Decision Report

Application for Works Approval

Works Approval Number W2843/2025/1

Premises Christmas Island Phosphates
Christmas Island
INDIAN OCEAN TERRITORIES WA 6798

Figure 2: Conceptual landfill design with proposed closure capping shown in green (PRL, 2024)

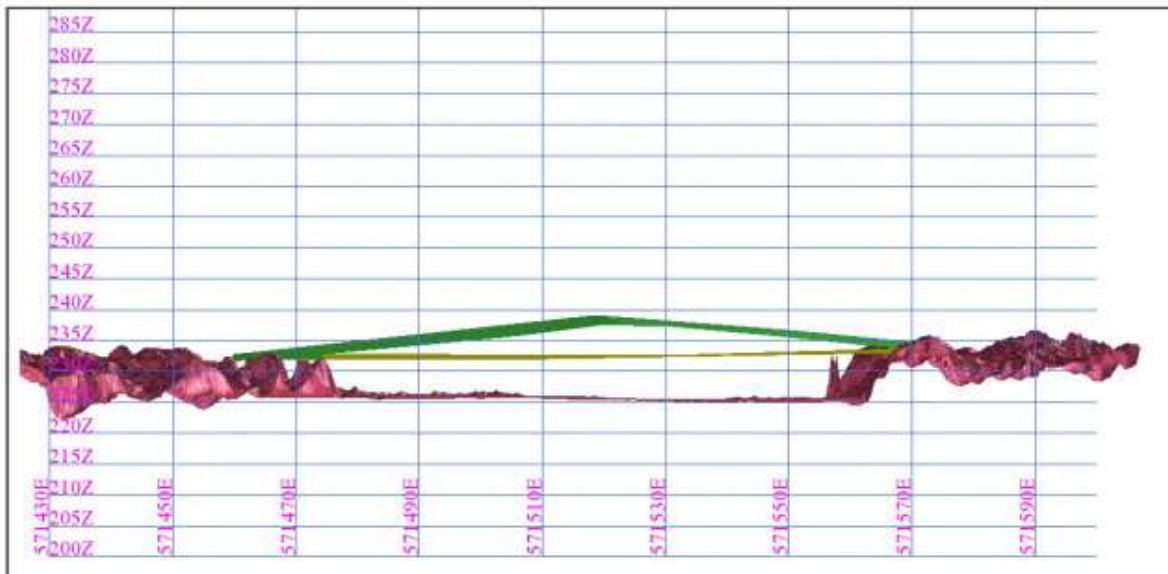
Condition	Summary of applicant's comment	Department's response
	 Figure 2: Conceptual landfill design with proposed closure capping shown in green (PRL, 2024) The closure cover will be constructed via trucks, excavator and dozer so it will be traffic compacted on the already pushed up waste and operational cover increasing the long term stability of the cover. The 2% fall is so that water runs off from the landfilling area which avoids water pooling on the cover and reduces risk of subsidence. The low angle (2%) will minimise erosion from the surface of the cover. A pre and post-closure cover survey will be taken using a drone. With a pre-relinquishment survey and inspection (with DEMIRS) required. The area requires to be made safe to meet closure requirements of the tenement. PRL pay a conservation levy as part of the lease which releases PRL from rehabilitation requirements beyond 'making safe'."
